Project Title: Refurbish Elevators and Replace Controls

Solicitation Questions and Answers
for
Refurbish Elevators and Replace Controls
Project: 437-22-101, RFP: 36C26324R0021
12/15/2024

Solicitation Questions and Answers (updated 3-26-2024) for
 Refurbish Elevators and Replace Controls
 Project: 437-22-101, RFP: 36C26324R0021

4 FLOOR PLAN - INDEPENDENCE 4,5 - TYPICAL
1/4" = 1'-0"

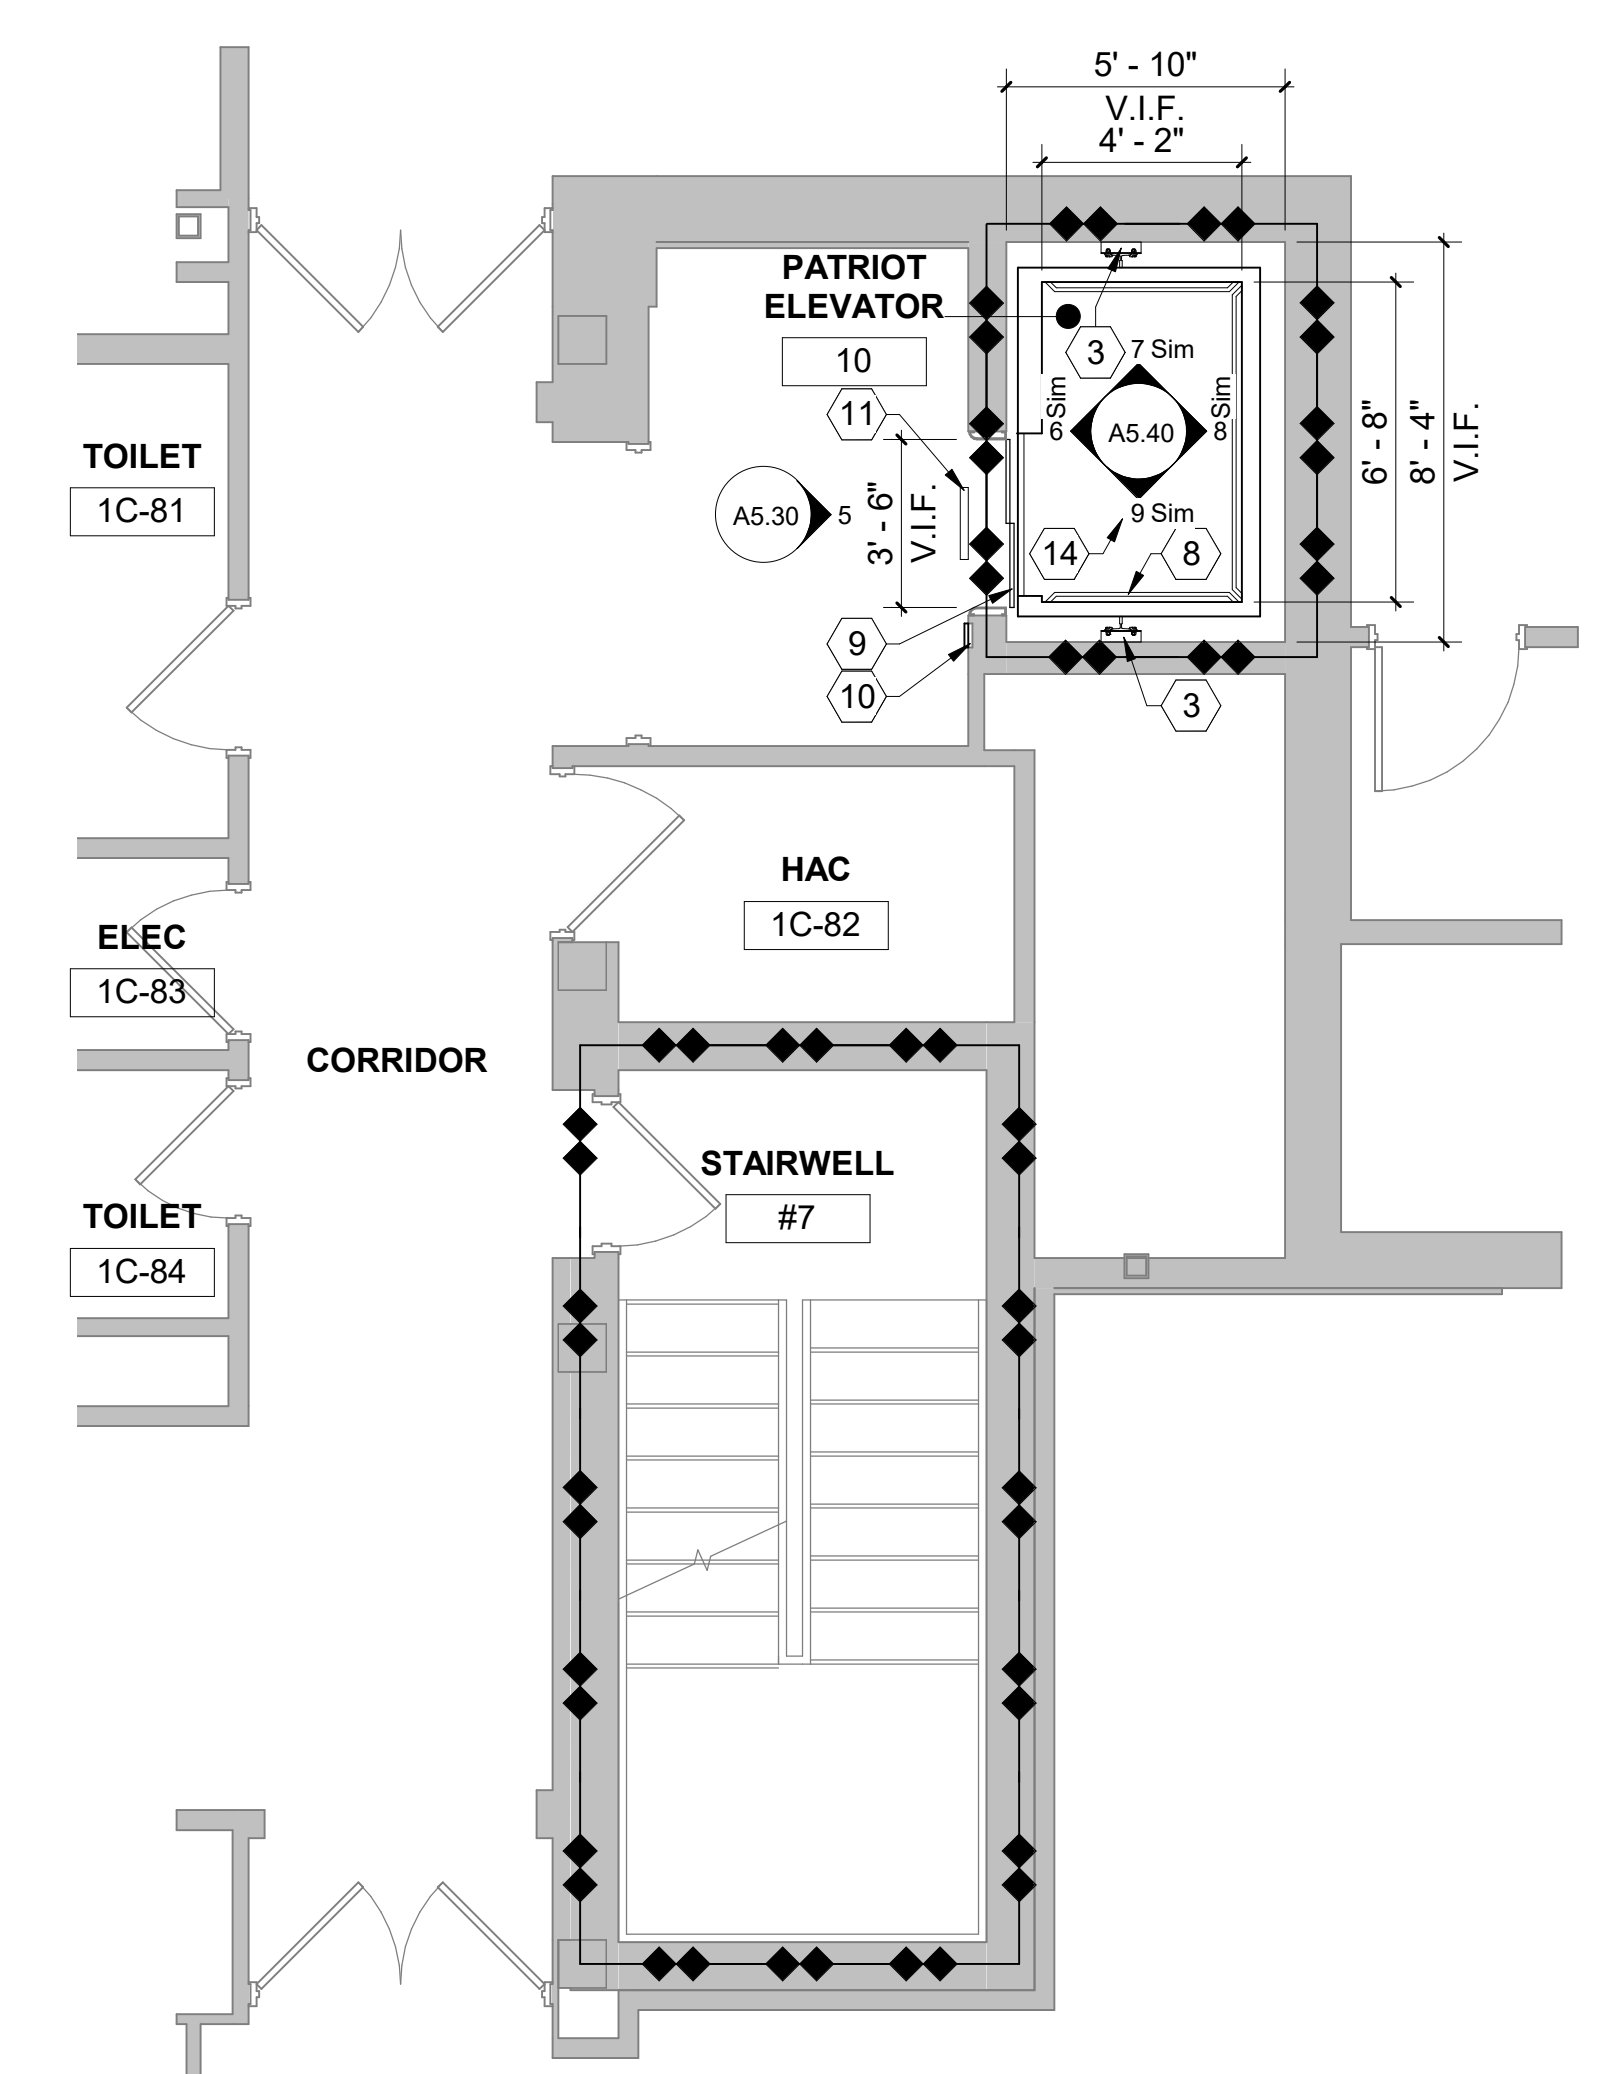
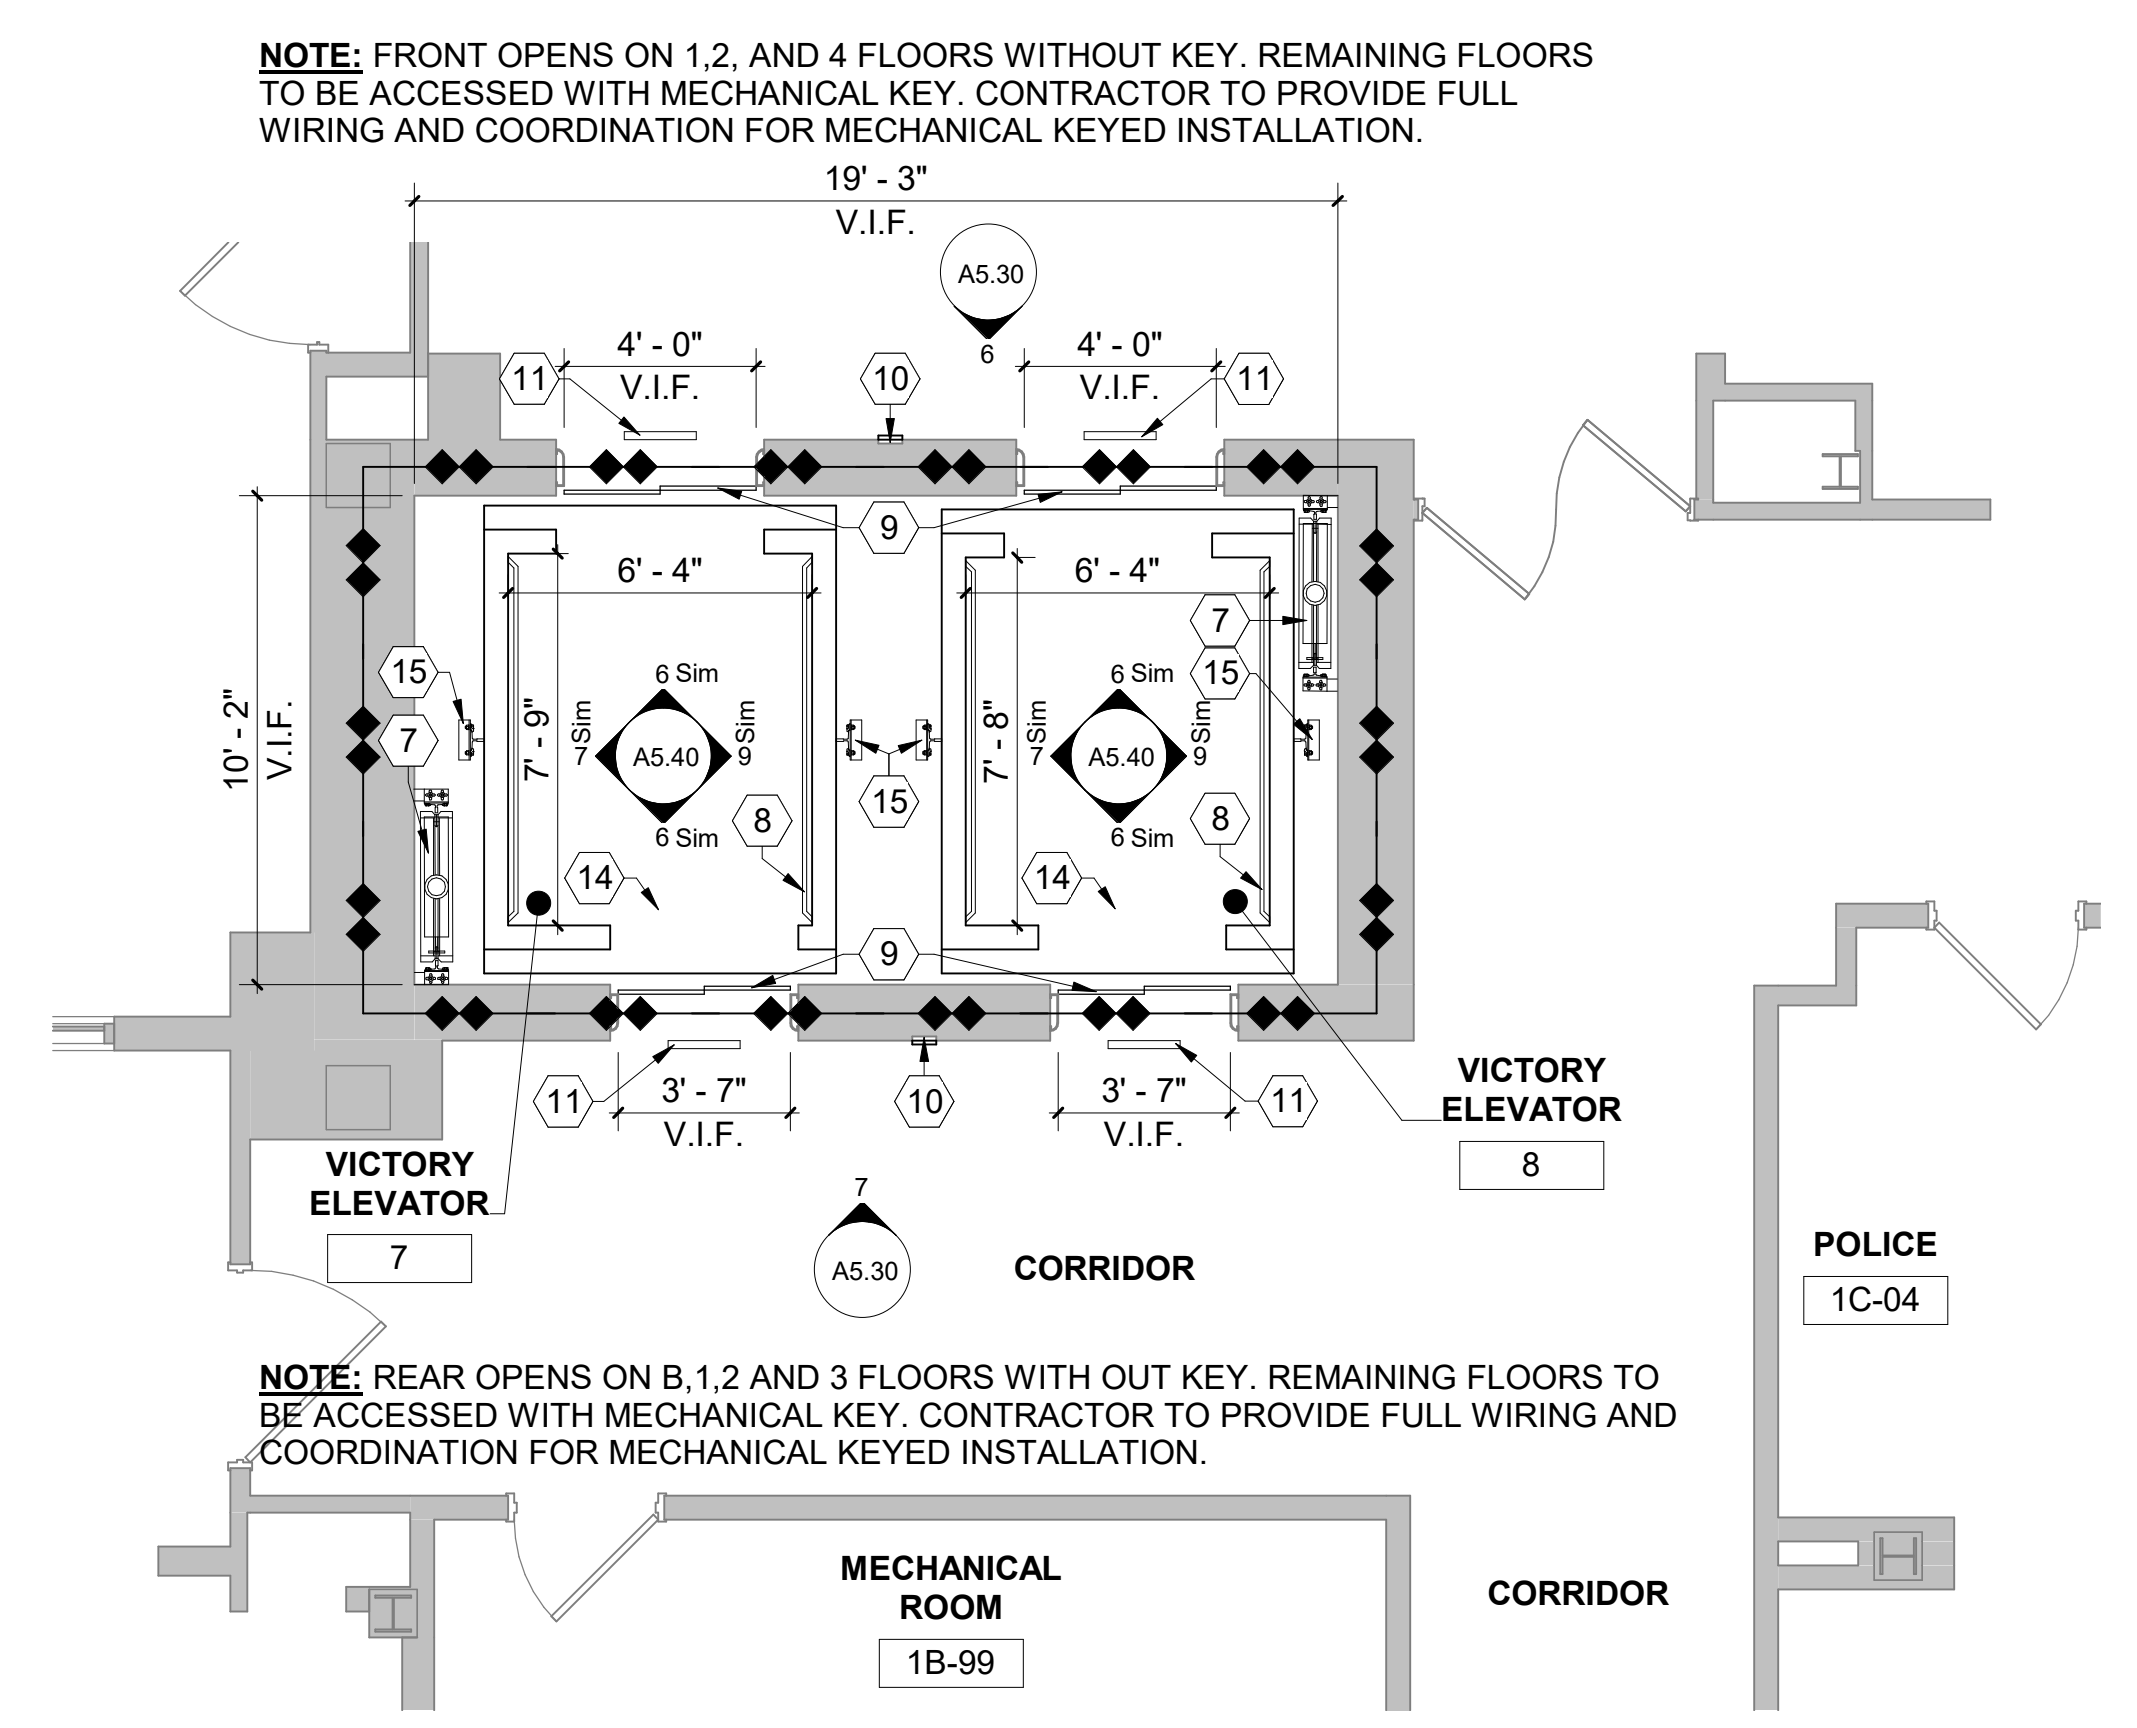
Drawing Sheet A5.21 ENLARGED PLANS – See revised drawing sheet for the inclusion of additional floor repair to support the installation of underfloor plumbing at Elevator #10.

Drawing Sheet A5.21 ENLARGED PLANS – See revised drawing sheet for the adjustment of keynotes # 3, 9, 15.
